SUBJECT: PALISADES NUCLEAR PLANT - NRC INTEGRATED INSPECTION REPORT
05000255/2013003

Report No: 05000255/2013003

Facility: Palisades Nuclear Plant

Section A-A

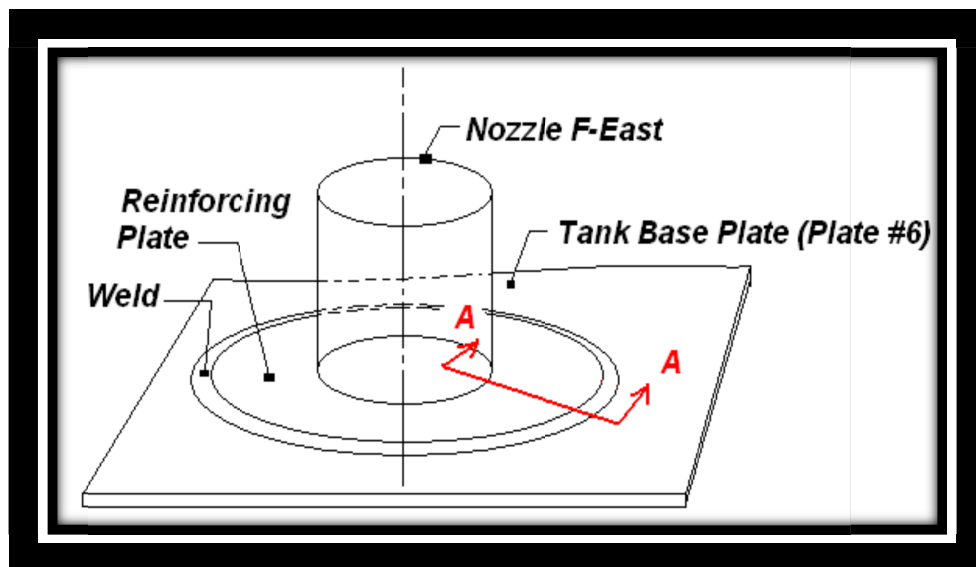
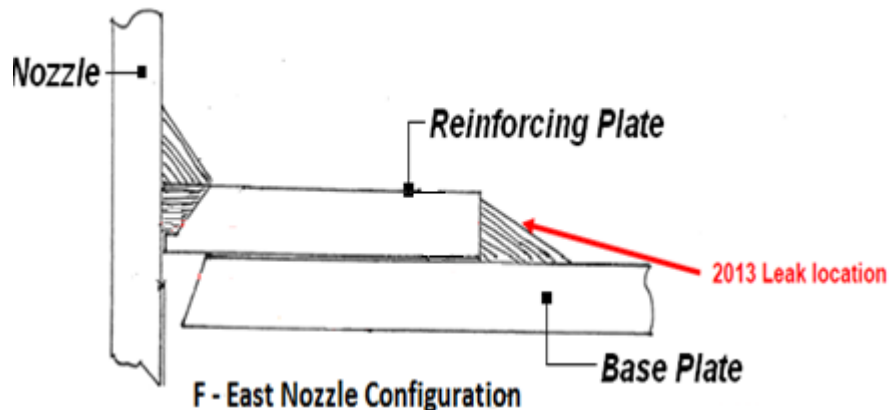
Inadequate Control of Welding at the F-east Nozzle Reinforcement Plate

Introduction: A finding of very low safety significance (Green) and associated NCV of 10 CFR 50 Appendix B Criterion IX, "Control of Special Processes," was identified by the inspectors for the licensee's failure to perform adequate pre-weld cleaning and control the welding process in a manner that ensured proper weld fusion of the F-east nozzle

The fillet weld 12C1 connected the tank floor plate to the 23.5 inch diameter by 5/16 inch thick aluminum alloy 6061-T651 reinforcement plate around the 18 inch diameter F-east nozzle. The weld repair was made by manual gas tungsten arc welding (GTAW) with aluminum alloy R5356 filler material. The tank floor plate was constructed of 5454 series aluminum alloy (see figures below- not to scale).

During vacuum box testing of welds inside the SIRWT, the licensee identified a 3/16 inch long circumferentially oriented crack in the F-east nozzle reinforcement plate weld. The licensee removed a 6-inch diameter section of this weld containing the flaw utilizing a hole-saw. The removed sample was sent to the licensee's vendor, Babcock and Wilcox (B&W) Technical Services Group, for destructive examination. In the B&W report titled, "Laboratory Analysis of a Leaking Tank Weld from Palisades," the vendor identified the following:

In Work Order 00319746-12, "T-58 - Safety Injection Refueling Water Tank - Install Reinforcing Plates Over Nozzle F (E & W)," no instructions were provided following cutting operations for shop personnel to clean the aluminum plate material for use as reinforcement support on the F-east nozzle of the SIRWT. Specifically, no instruction was provided to apply a chemical cleaning agent following cutting of the plate material to remove dirt, oil or cutting fluids. Instead, the licensee relied on the vendor welding procedure 2223 Ar MN-GTAW, which stated, "Initial cleaning. Wire brushing, grinding, filing, chipping and/or deburring," and "(b) Welds shall be cleaned between each pass. Interpass and final cleaning shall be by wire brushing, grinding, filing, chipping and/or deburring." Cleaning prior to welding was required by Section 5.2 of the SIRWT construction code USAS B96.1-1967 and was essential to ensure proper weld joint fusion as required by the B96.1 Code. Additionally, the following source documents illustrate the importance of thoroughly cleaning aluminum prior to welding to achieve adequate fusion between the weld metal and base metal.

In response to the 2013 leakage event, the licensee subsequently replaced the SIRWT floor and included instructions in the floor replacement work order that required pre-weld cleaning with acetone or other approved solvents. The licensee entered the failure to perform adequate pre-weld cleaning and control the vendor welding process in a manner which would ensure proper weld fusion into the CAP as CR-PLP-2013-03185.
